Subject: ELECTRIC PARKING BRAKE (EPB) WARNING LIGHT ON / EPB WILL NOT RELEASE IN COLD WEATHER	Bulletin No: 04-002/15
	Last Issued: 07/14/2015

2016 CX-5 vehicles with VINs lower than JM3KE*****676325 (produced before June 9, 2015)

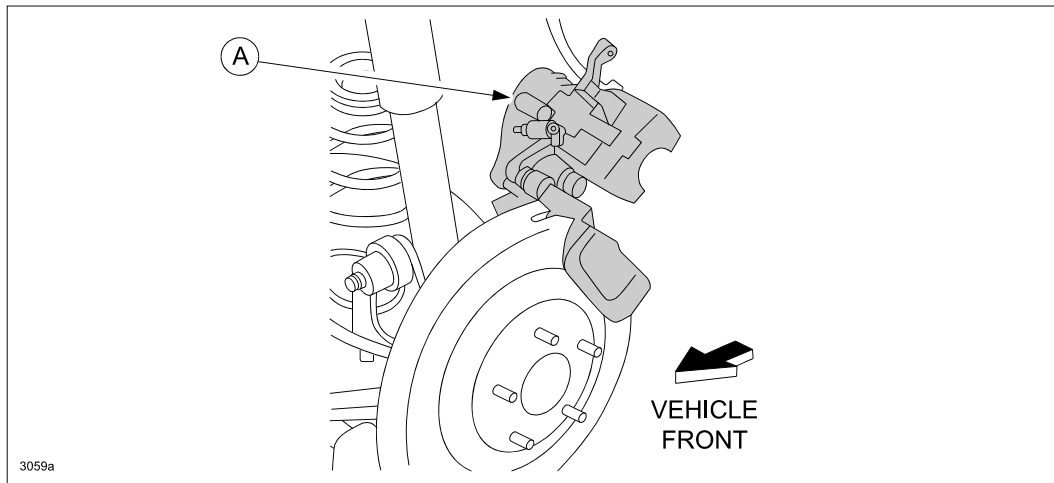
This condition occurs when pressing the EPB switch to release the electric parking brake, however, the EPB will not release.

This concern may be caused by the EPB motor gear unit (A) dimensions being out of specification. The machining dimensions of EPB motor gear unit have been improved to eliminate this concern.

1. Verify the customer concern.
 - If DTCs C2005:19 (RH) and/or C2006:19 (LH) are present, proceed to Step 2.
 - If DTCs C2005:19 (RH) and/or C2006:19 (LH) are not present, this bulletin is NOT applicable. Proceed with normal troubleshooting procedures according to MS3 online or the workshop manual.
2. Replace the Electric Parking Brake Motor Gear Unit and Rear Brake Caliper(s) according to the instructions on MS3 online or the Workshop Manual (section 04-12 ELECTRIC PARKING BRAKE MOTOR GEAR UNIT REMOVAL/INSTALLATION and (section 04-11 CALIPER (REAR) DISASSEMBLY/ASSEMBLY).
3. Verify the repair.
